Rezoning Transportation Analysis

Petition Number: 2021-119

Date	Description
09-23-2021	First Review (KP)
11-22-2021	Second Review (KP)
12-20-2021	Third Review (KP)

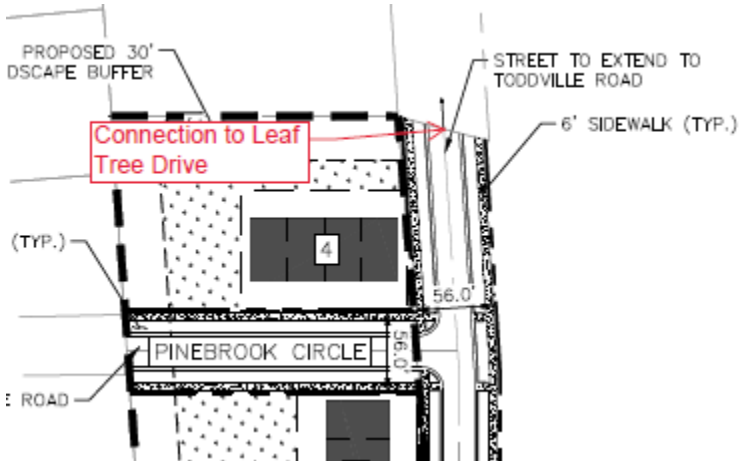
2. ~~Revise site plan and conditional note(s) by classifying each proposed public street in accordance with the USDG Street Cross Sections depicted in the Charlotte Land Development Standards Manual.~~

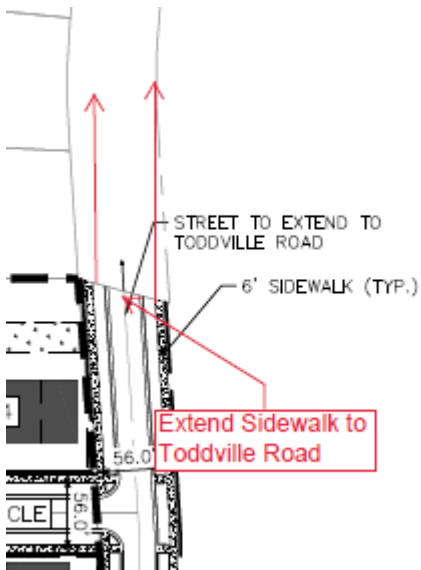
3. ~~Revise site plan and conditional note(s) by committing to connecting proposed Public Street B to existing Leaf Tree Drive. This connection will be subject to CDOT approval during permitting.~~

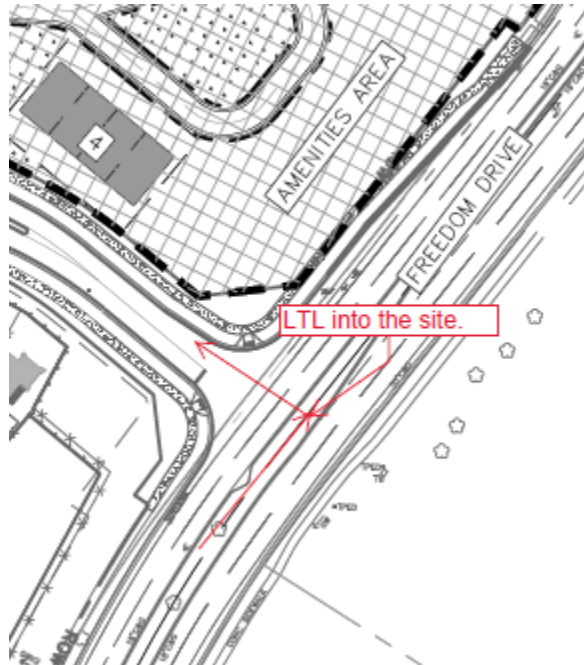
4. ~~Revise site plan and conditional note(s) by committing to extend the sidewalk along proposed Public Street B, and existing Leaf Tree Drive, and connect to the existing sidewalk at the intersection of Toddville Road and Leaf Tree Drive. Additionally, the appropriate PROWAG and ADA curb ramps will be constructed at the intersection of Toddville Road and Leaf Tree Drive.~~

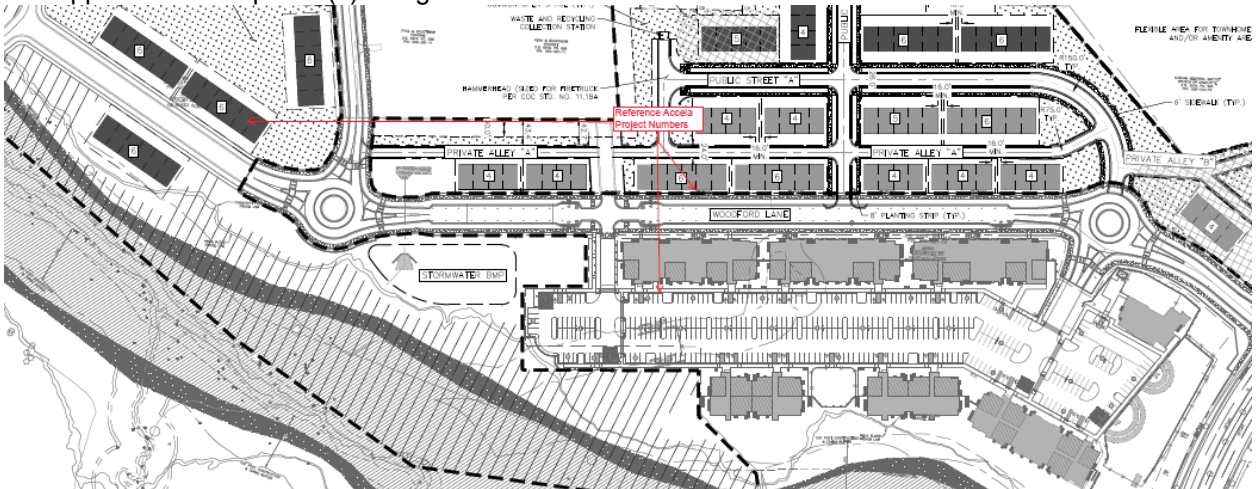
5. ~~Revise site plan and conditional note(s) by committing to coordinating with NCDOT, during permitting, to construct a westbound left turn lane, with 100 feet of storage and appropriate bay taper length, on Freedom Drive to turn onto Woodford Lane. The appropriate storage and bay taper lengths will be subject to NCDOT approval.~~

Update to Comment as a Result of the 11-15-2021 Site Plan: Revise Site Plan Note 2 to: "Developer will coordinate with NCDOT, during permitting, to construct a left turn lane on northbound Freedom Drive to turn onto Woodford Lane. The left turn lane will be subject to NCDOT standards and approval"

- 2) DEVELOPER TO COORDINATE WITH NCDOT, DURING PERMITTING, ~~REGARDING A POSSIBLE WESTBOUND LEFT TURN LANE FROM NORTHBOUND FREEDOM DRIVE.~~
- 3) ARCHITECTURAL TREATMENTS AND/OR WINDOWS TO BE PROVIDED TO AVOID BLANK WALL EXPANSES GREATER THAN 20'.

"to construct a left-turn lane on NB Freedom Drive to turn onto Woodford Lane. This turn-lane will be subject to NCDOT approval."

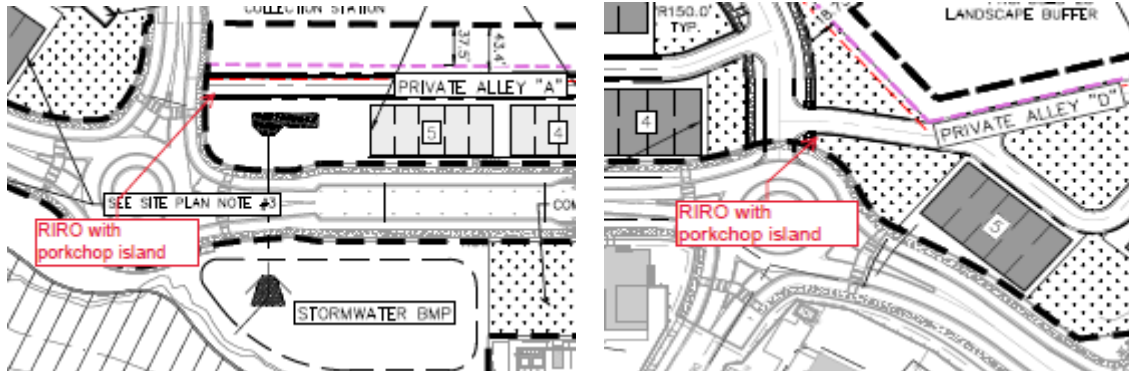
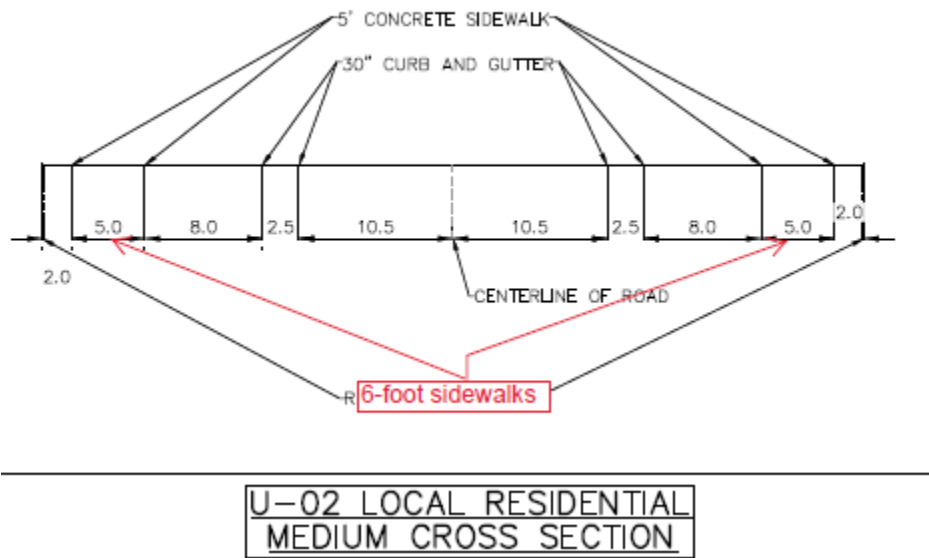
10. ~~**New Comment as a result of the 11-15-2021 Site Plan:** Revise the site plan and conditional notes to commit to provide right in right out ingress and egress at the intersections of Private Alley D and Public Street A and Private Alley A and the approved public street associated with the Freedom Flats Multifamily Development (LDGP-2020-00201). A porkchop island shall be utilized on Private Alley D~~

and Private Alley A, with appropriate ADA pedestrian accommodations, to direct the right in right out movements.
